# **EAST YORKSHIRE SOLAR FARM**

**Applicant's Responses to Examining Authority's Second  
Written Questions**

**Document Reference: EN010143/APP/8.45**

**FIGURE NUMBER**  
Appendix A Figure 1

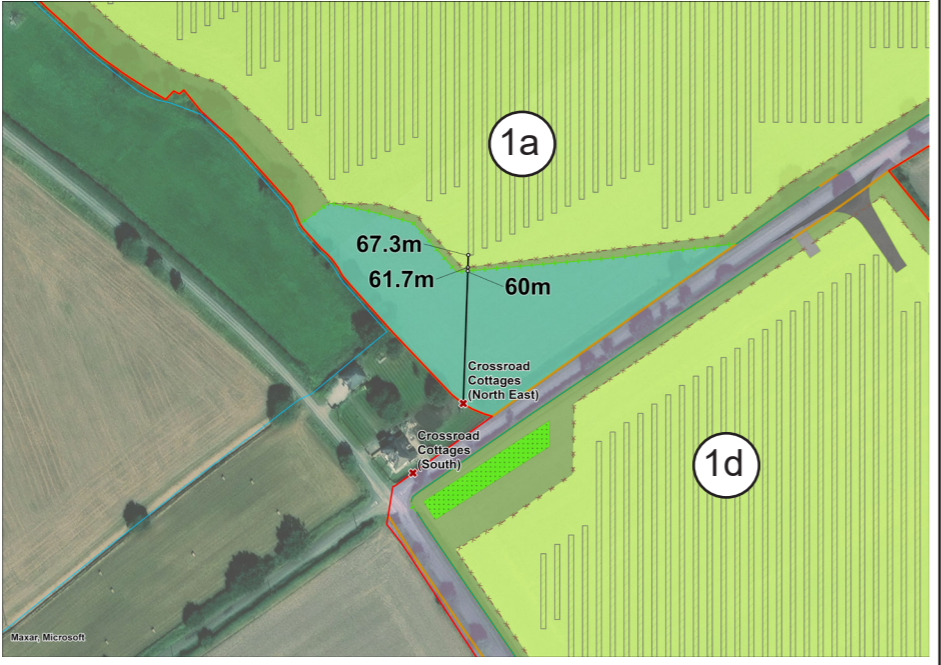
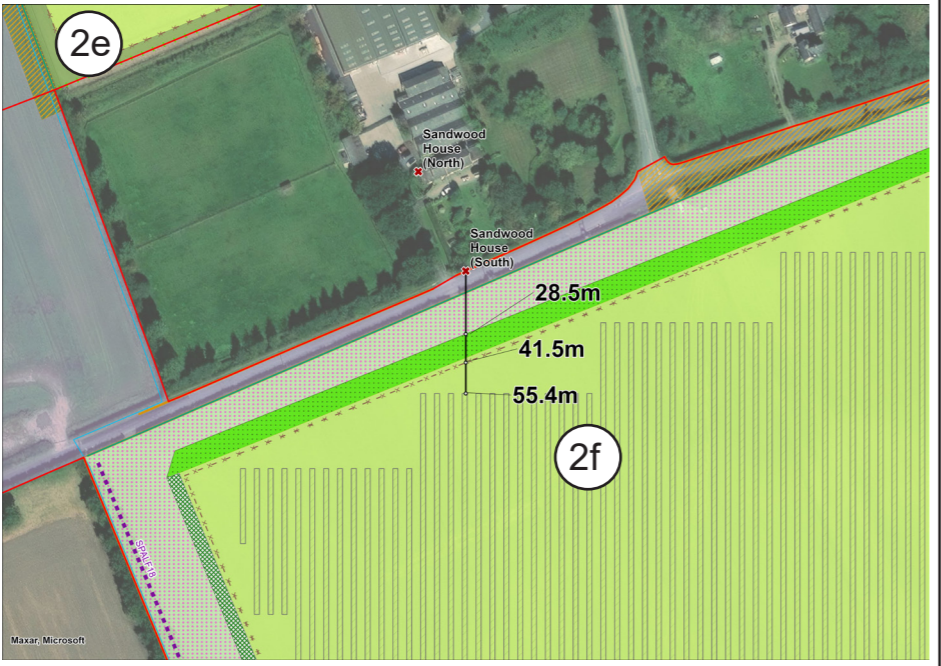
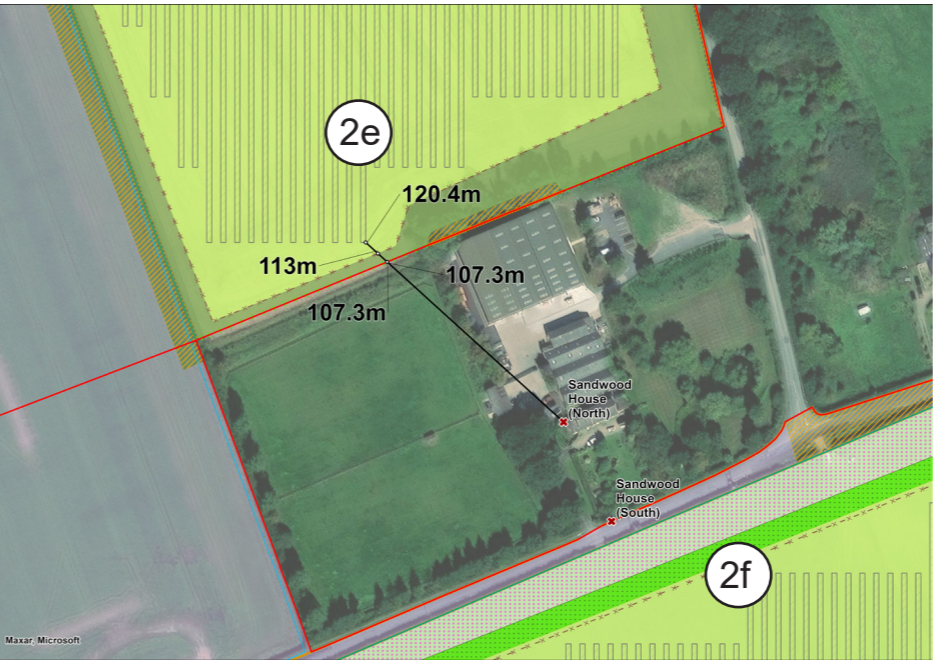
ExQ1	Respondent	Question	Applicant's Response
		<p>Please comment further on the cumulative impact of this change and whether there is potential to amend the layout and / or planting proposals in these locations and reduce any foreshortening / enclosing effects.</p>	<p>of 5 metres from the fence to reduce the foreshortening/ enclosing effects, this providing an overall 50m corridor. Part of PRow WRESF07 has Solar PV panels to one side (south side), however, is separated from the Solar PV panels to the north by the railway line.</p> <p>As outlined in the response to ExQ1 Q9.0.19 <b>[REP1-081]</b> there are intermittent sections of low-level woodland edge planting proposed along the boundary of the PRow buffers as illustrated on Section D in Appendix A of the Framework Landscape Masterplan (Revision 2) <b>[REP3-016]</b>.</p> <p>Section D illustrates this for the landscape mitigation buffers to the east and west of Footpath FOGGF05 (to the south of Gribthorpe), where vegetation is proposed to soften the view of fencing and Solar PV panels.</p> <p>The effects on recreational users of all PRows within the Order limits are set out within Section 10.7 of ES Chapter 10: Landscape and Visual Amenity <b>[AS-014]</b>. This includes the potential visual effects of the Scheme for receptors who will experience transient views in locations where there are Solar PV panels on both sides of the PRow.</p> <p>The conclusions within Chapter 10 are presented on this basis, therefore, no amendments are proposed to the layout of the Scheme or planting proposed in the Framework LEMP (Revision 2) <b>[REP3-016]</b> due to the measures already undertaken, and outlined above, to further reduce the foreshortening/ enclosing effects.</p>

ExQ1	Respondent	Question	Applicant's Response
			<p>Appendix B of this response document includes figures showing the residential properties (including Sandwood House but excluding the property visited at Newshome) visited during the Accompanied Site Inspection (ASI) on 11 July 2024 in relation to the Solar PV Site. Measurements are provided in Appendix B illustrating the minimum distances of some of the key elements of the Scheme in relation to the residential property and its curtilage. Measurements include distances to the Scheme Boundary, Solar PV fencing and Solar PV panels to provide clarity regarding the proximity of the Scheme and the proposed landscaping and ecological enhancements.</p> <p>As such, no further amendments are required for or proposed to the Scheme applied for.</p>
Q7.0.5	The Applicant	<p>ExQ1 Q9.0.19 sought further information on the cumulative foreshortening / enclosing effect of planting and fencing on extensive views. The response <b>[REP1-081]</b> refers to “a degree of foreshortening of the view for a small number of locations”. However, reference to the LEMP Masterplan [REP3-017] and ES Figure 2-2 PRoWs [APP-137] suggest that parts of FOGGF13, FOGGF05, SPALF14, SPALF15, SPALB08, EASTB17, BUBWF10, WRSF06, WRESF08, WRESF09, WRESF07 would have solar arrays on both sides.</p>	<p>Paragraph 1.6.8 d of ES Chapter 10: Landscape and Visual Amenity – Rev1 <b>[AS-014]</b> sets out the principles which have been embedded into the design in order to mitigate potential adverse landscape and visual effects and have informed the width of offsets to PRoW throughout the Scheme. This includes where there are Solar PV panels to both sides.</p> <p>It is noted that sections of the PRoWs listed (FOGGF13, FOGGF05, SPALF14, SPALF15, SPALB08, EASTB17, BUBWF10, WRESF06, WRESF08, WRESF09) would have sections where there are Solar PV panels on both sides.</p> <p>Where this is the case, an offset of 20 metres is applied to each side of the PRoW, forming a 40 metre wide strip to the Solar PV fence. The Solar PV panels are set back a minimum</p>
